Re: Final Remedial System Optimization Report
Occidental Chemical Corporation, Buffalo Avenue Plant
NY Permit Number 9-2911-00112/00167-0

Final Remedial System Optimization Report

**Occidental Chemical Corporation
Buffalo Avenue Plant
Niagara Falls, New York**

OMP Figure 1.2

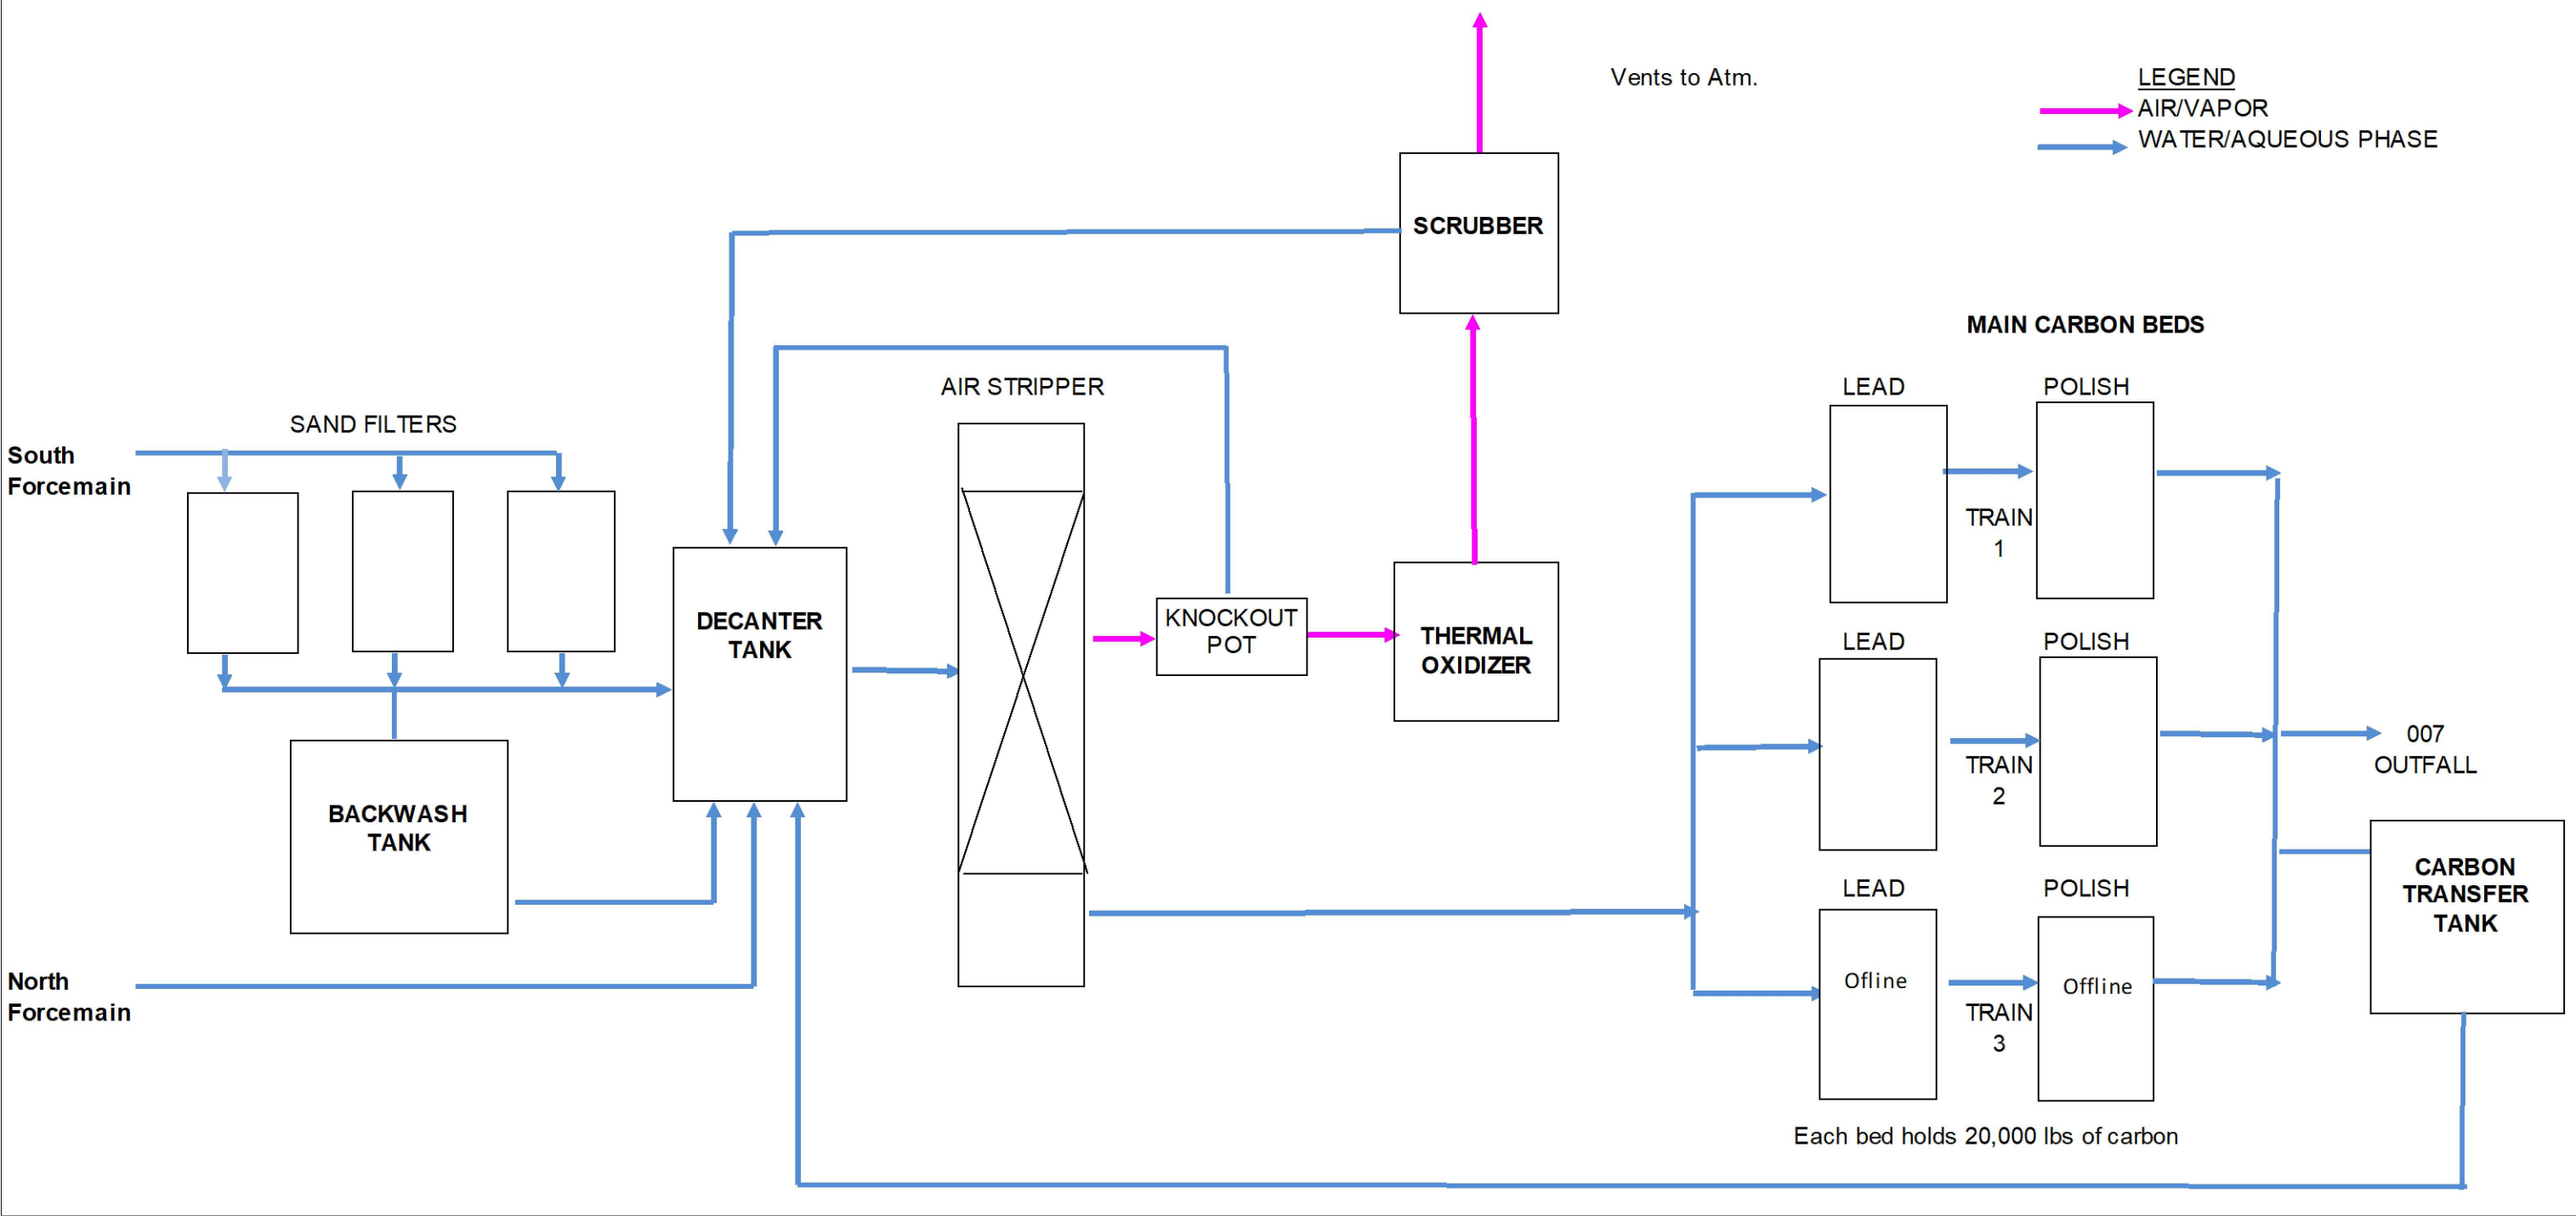
Figure 1.2, Flow Diagram: it is requested that the vapor and aqueous phase flowlines be shown as different symbols and/or with different colors on this figure. Clarification is also requested regarding the flow path from the carbon bed effluent to the scrubber.

See revised Figure 1.2. Aqueous phase flowlines are now colored blue. The flow path from the carbon bed effluent to the scrubber does not exist and has been removed.
